AGENDA MEMO
PLANNING AND ZONING COMMISSION
MEETING DATE: September 2, 2015

PZC 2015-07: Republic Bank – Kiddie Academy, 1502-1510 75th Street: Petitioner requests final plat of subdivision approval for a 2-lot subdivision and a variation approval from the Zoning Ordinance to reduce the required distance a driveway is located from a street intersection from 50 feet to 33.5 feet.

Subject: Kiddie Academy
1502 75th Street
(CBBEL Project No. 95-323H185)

As requested, we have reviewed the final engineering plans, plat of subdivision, and supporting documents for the aforementioned property. The following comments must be addressed before we can recommend approval:

REPUBLIC CORPORATE PARK
PLAT OF SUBDIVISION

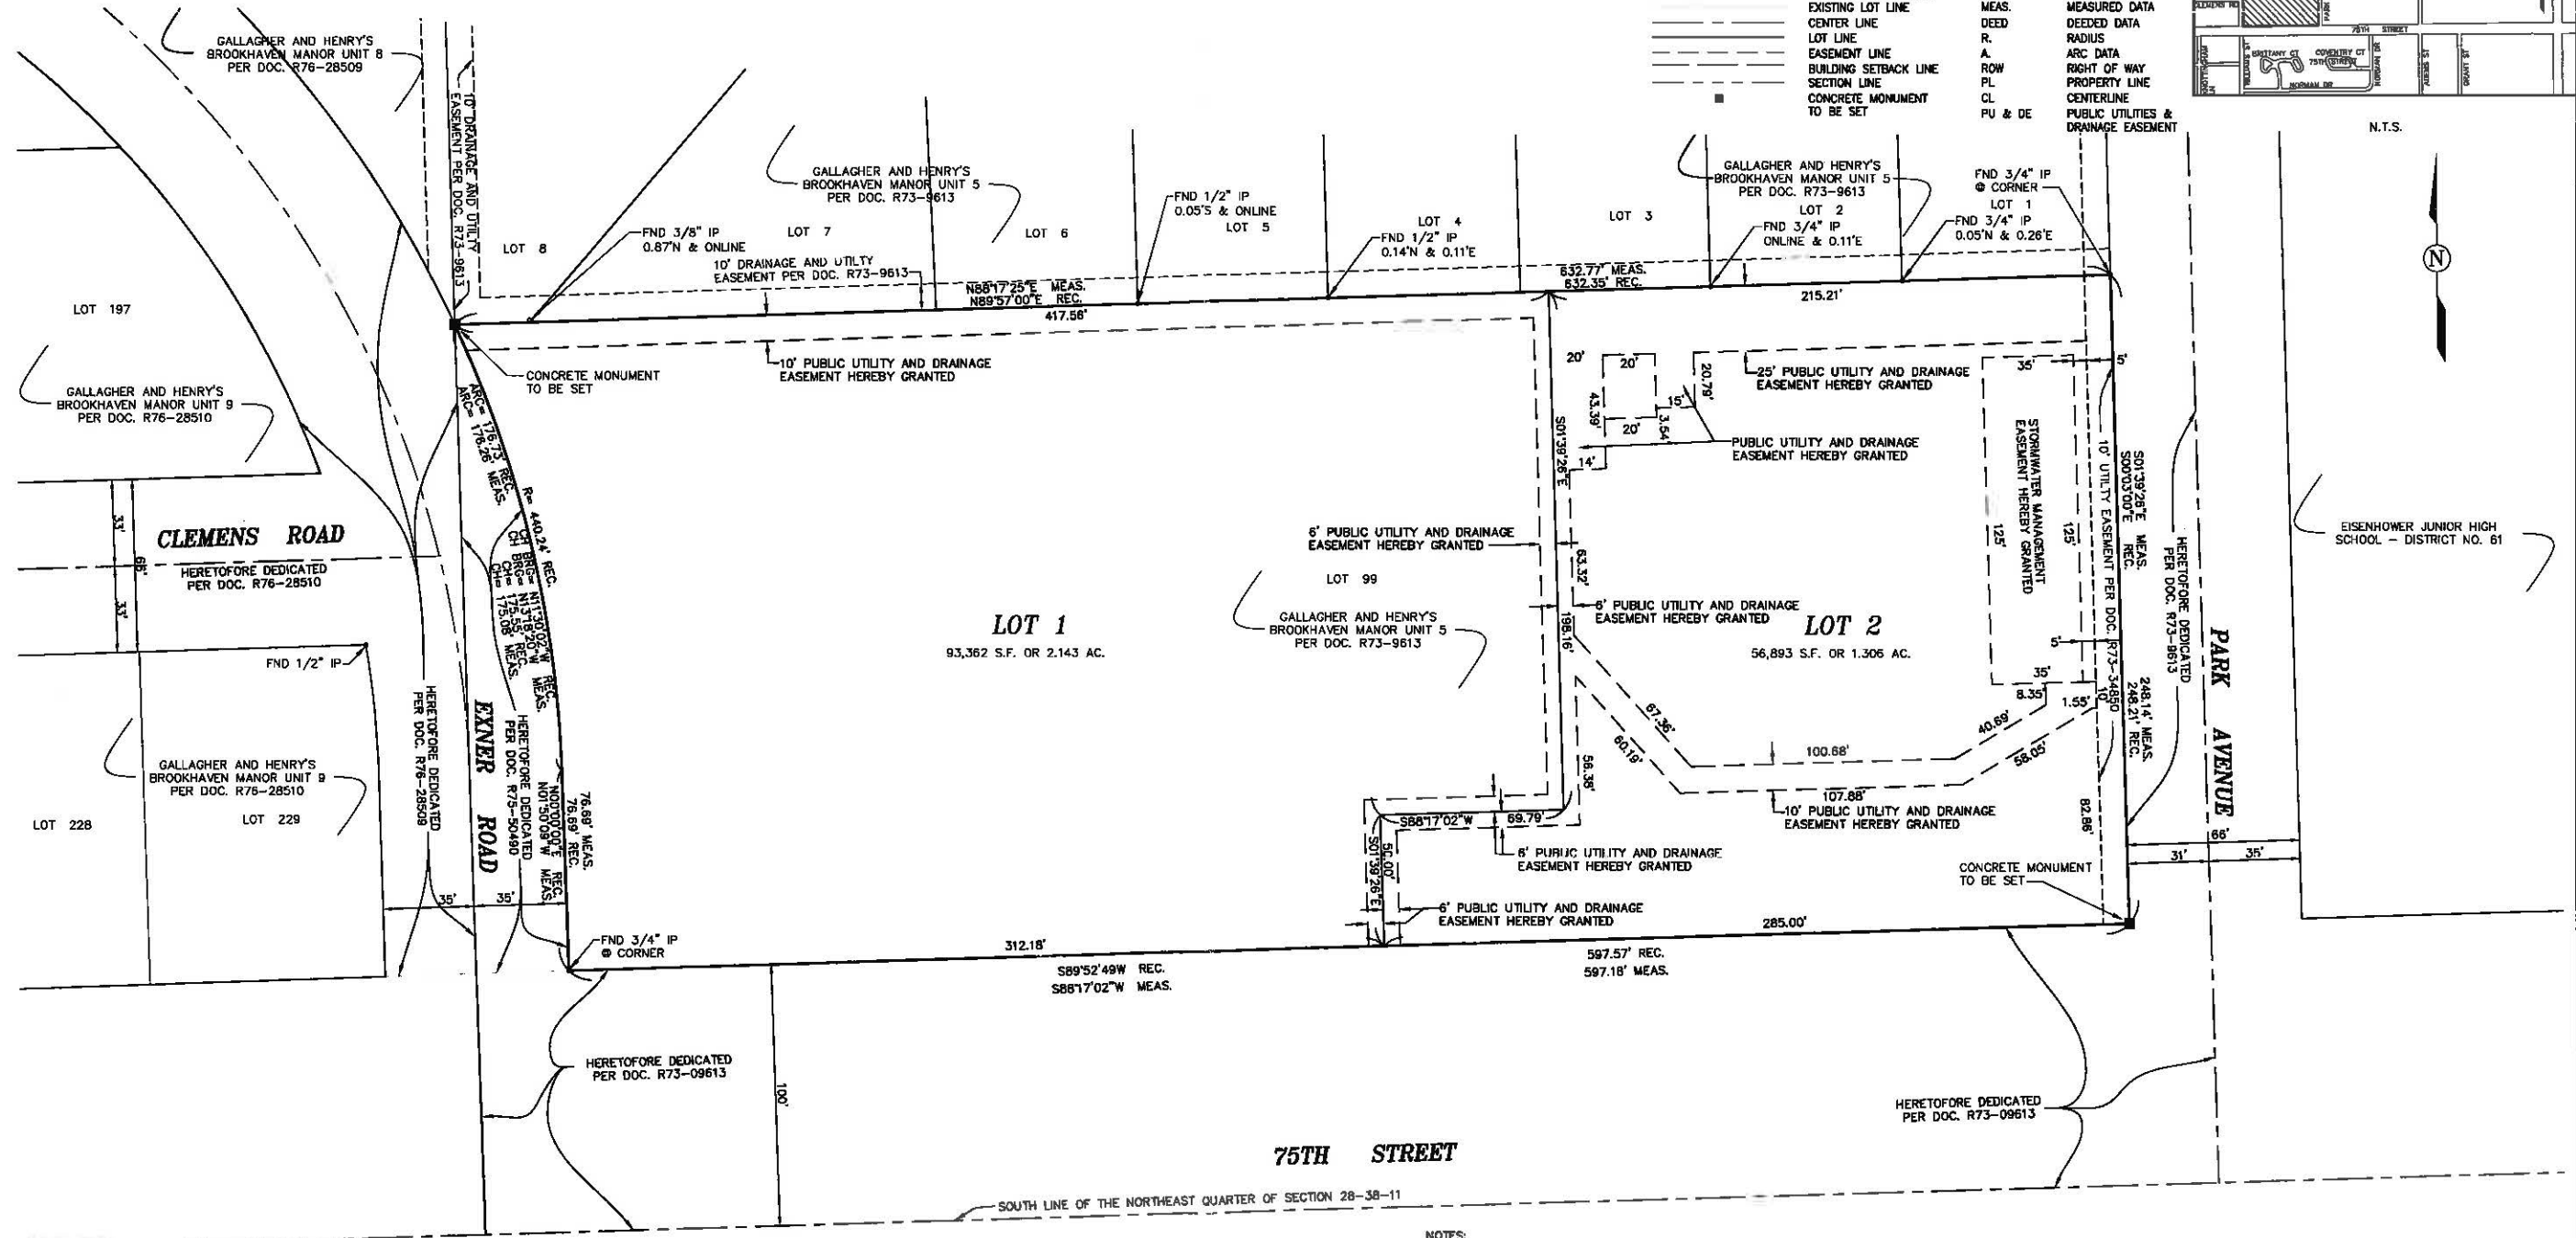
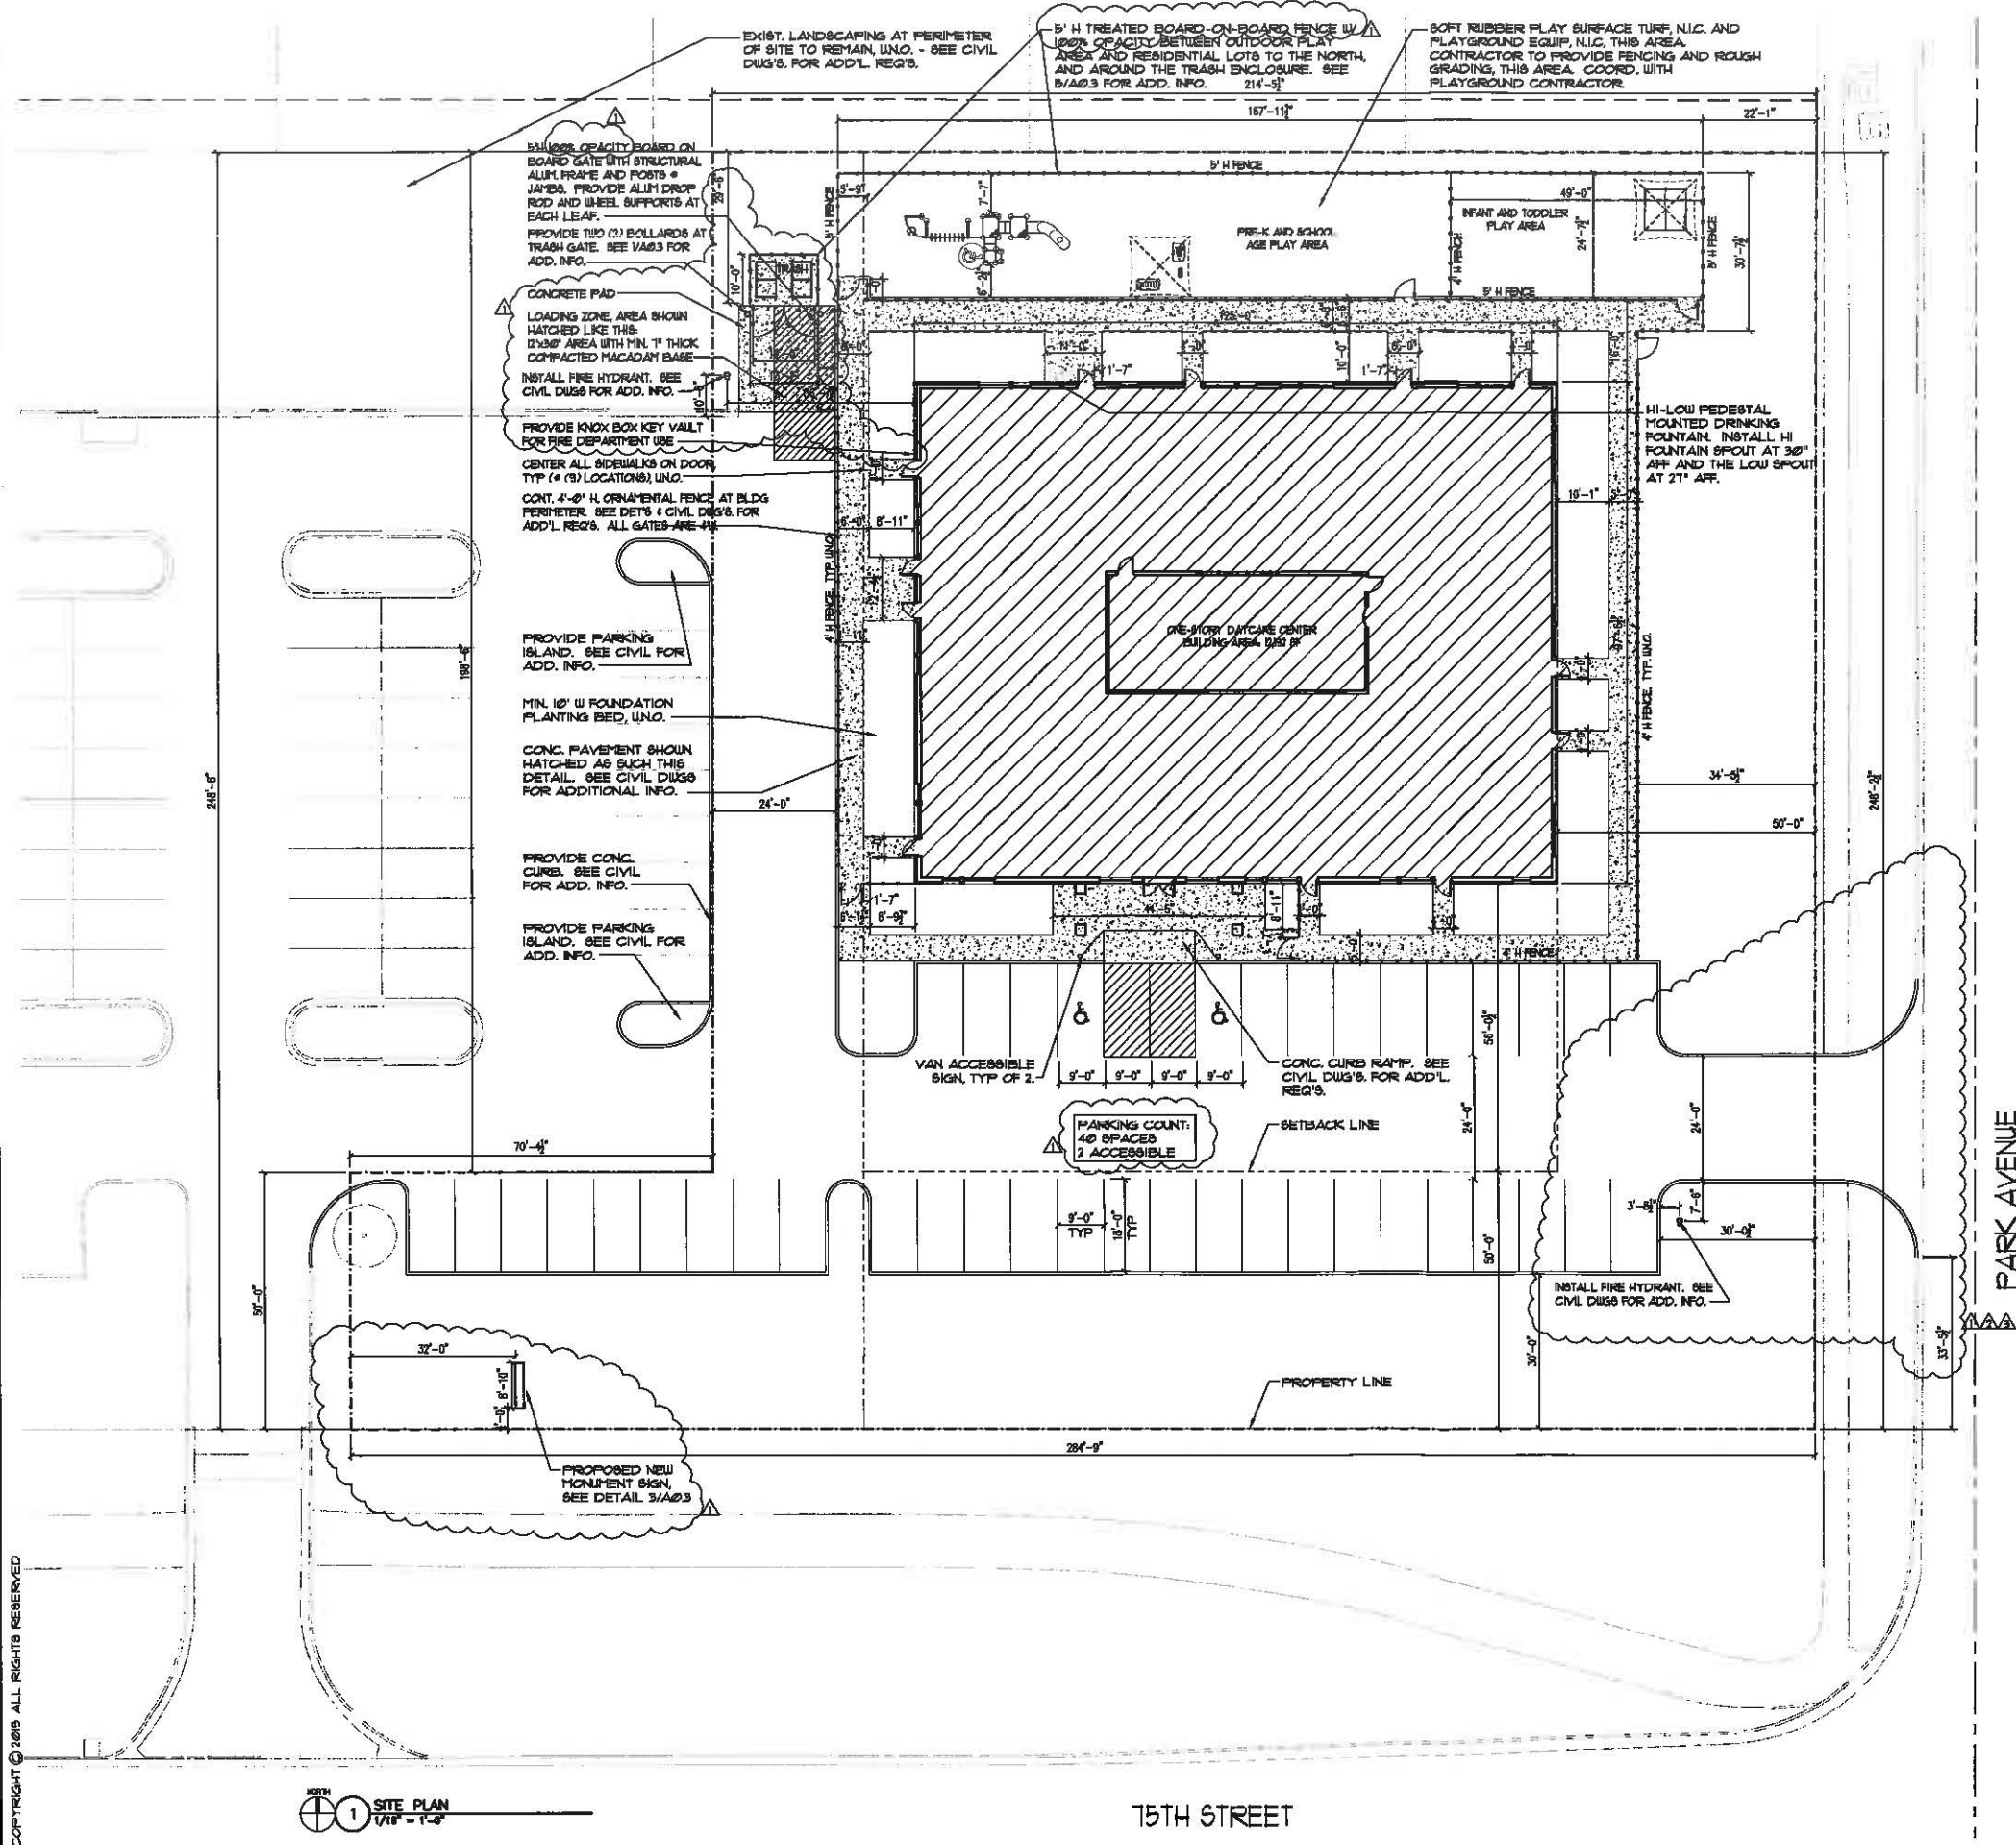
PLAT OF SUBDIVISION

The following comments are for the Plat of Subdivision as prepared by Roake and Associates and dated April 8, 2015.

1. Although easement provisions are provided for the detention easement, the detention easement has not been shown on the plat. All detention basins, including the existing basins on the bank property must be in easements.
2. Public Utility and Drainage Easement provisions must be added to the plat.
3. There must be either cross access easements on the plat or covenants providing for cross access.

1 SITE PLAN
1/16" = 1'-0"

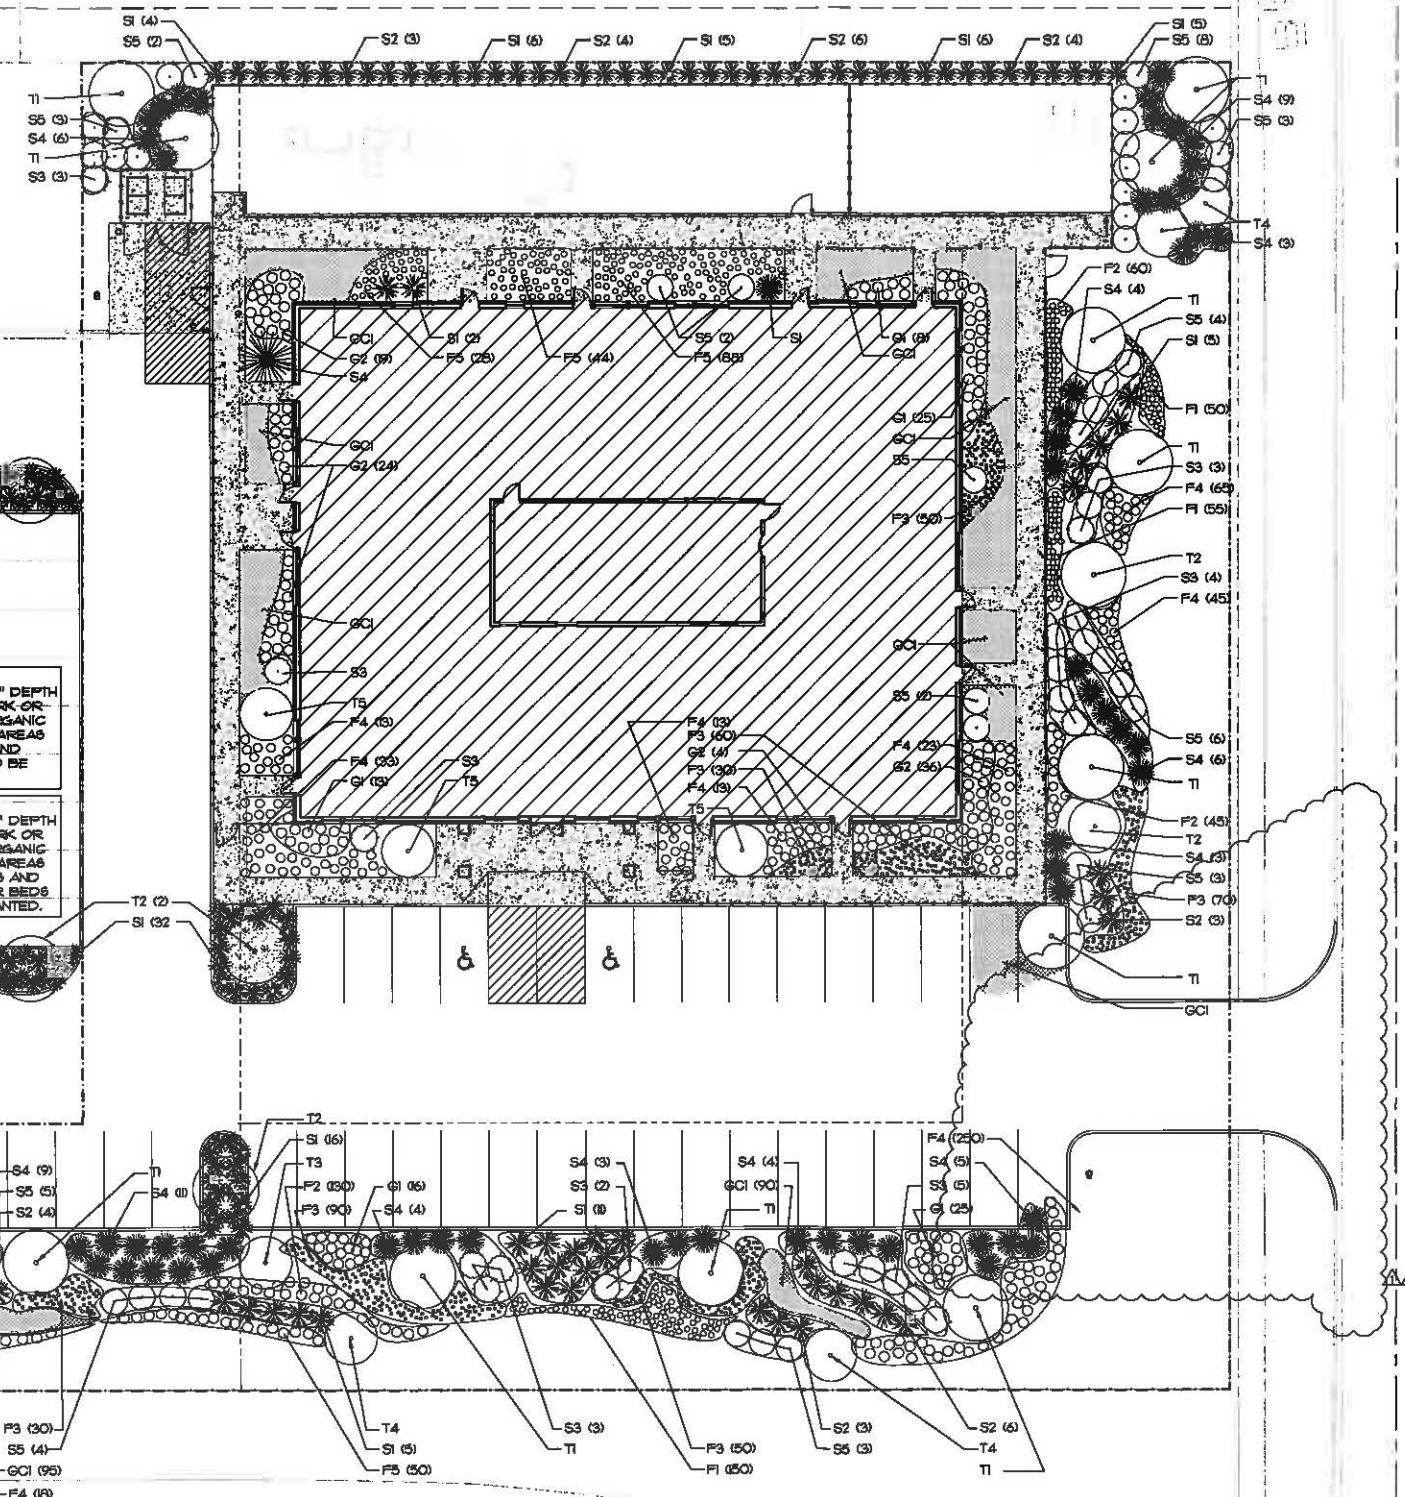
The site provides a privacy screening fence along the north side of the property, enclosing the play area. However, this fence is to be at least 6 feet tall to meet the Zoning Ordinance requirement for fencing between business and residential zoned properties. Staff notes the plan shows landscaping on the residential side of the fence.

Plan shows dumpster enclosure to be a 5-foot tall privacy fence. Staff recommends a masonry enclosure at least 6 feet tall.

The variation relates to the driveway off of Park Avenue. Within the business zoning districts, driveways are required to be located at least 50 feet from a street intersection, measured from the intersection of the street right-of-way and nearest end of the curb cut. The proposed setback is 33.5 feet. Staff supports this variation. Altering the driveway to comply with the code results in the driveway centerline being at an awkward angle off of Park Avenue, which staff finds does not meet the intent of the Zoning Ordinance nor is good site planning.

- 1. Address City Engineer's comments noted in letter from Dan Lynch, PE, Christopher B. Burke Engineering, dated June 19, 2015.**
- 2. Dumpster enclosure to be screened by masonry enclosure at least 6 feet tall.**
- 3. Privacy fence on north side of play area to be at least 6 feet tall.**
